Access Compliance Report

Public Rights-of-Way

(Pedestrian Signals)

Intersection ID: N/A	Main Street:	Cross Street: N/A	Location: N/A
ADA ID: 027BD375D213	Signal Type: Two Push Buttons-Non APS	Overall Compliance: No	Severity Score: BTN 1:N/A BTN 2: N/A No BTN: N/A
Codes/Mitigation Info/Possible Solution		Field Measurements/Component Compliance

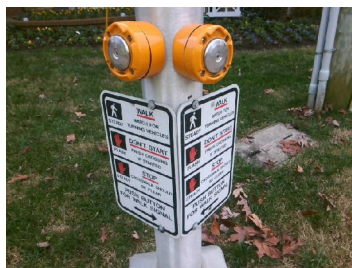
Possible Solutions: Replace Signal Push Button With APS Button on New Post. Remove & Relocate Sign.

PROW/ADA: TMUTCD 4e.08, R404.2, R406.2
